Springfield Township Planning Commission Meeting August 17, 2021

Reference: 1123 Ivy Hill Rd – Land Development

Re: MCPC # 21-0208-001
Plan Name: 1123 Ivy Hill Road
(1 lot comprising 0.907 acres)
Situates: Ivy Hill Road: Queen St. (S), Michener Ave. (N)

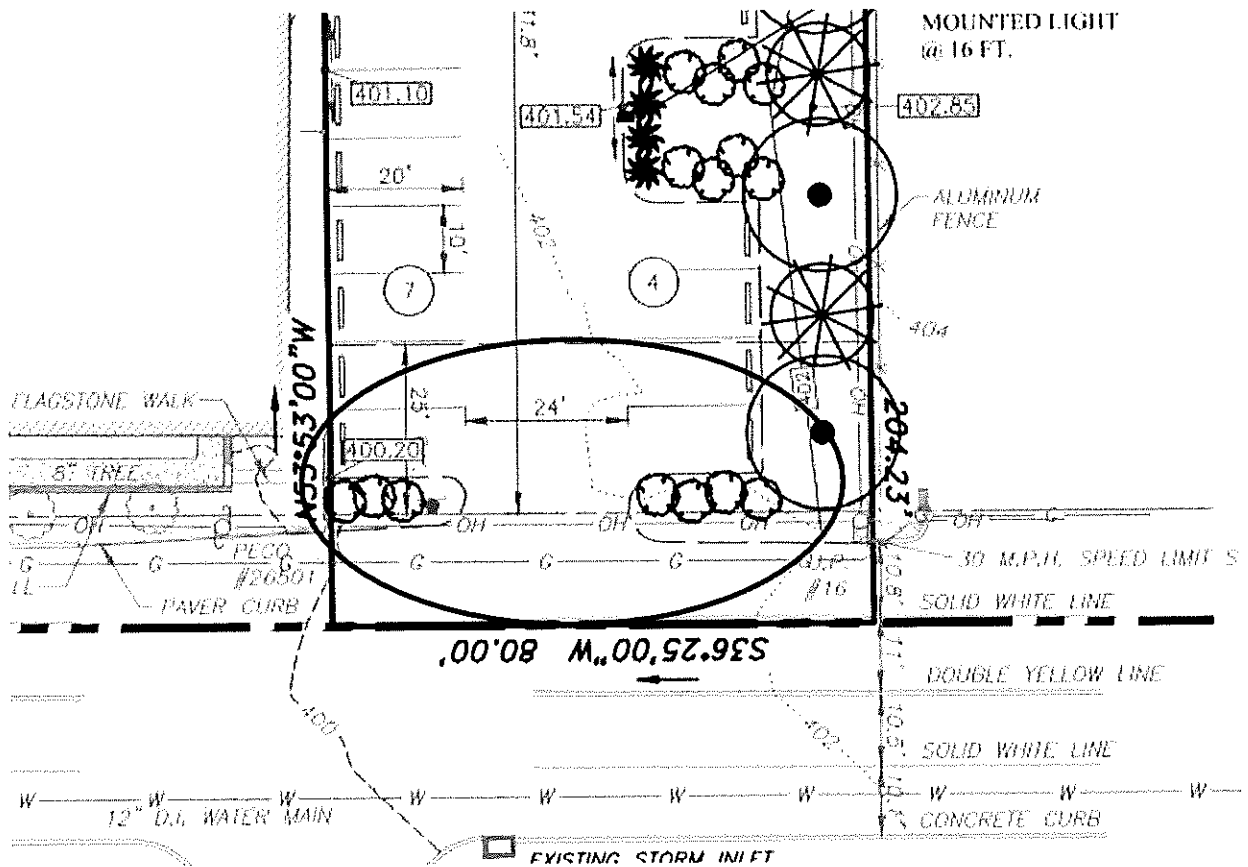
- A. Sidewalks. Sidewalks should be installed along the Ivy Hill Road frontage per § 95-10.1. As currently proposed there is not enough room for both a sidewalk and the landscaping area, due to the space required to meet the minimum parking requirements. Please reference comment below for a possible solution. The applicant could also consider a crosswalk across the access driveway of the site in lieu of a sidewalk.

- A. Shared Parking Agreement. In addition to the egress easement with the adjacent lot indicated on the plan, the applicant should consider a shared parking agreement that would allow existing parking spaces at 1101 Ivy Hill Road to count towards the parking requirements at 1123 Ivy Hill Road. At a minimum, this would allow for the removal of the two spaces along the

frontage of Ivy Hill Road entrance indicated in the image below. This would create enough space to add a sidewalk and possibly expand the landscaping area.
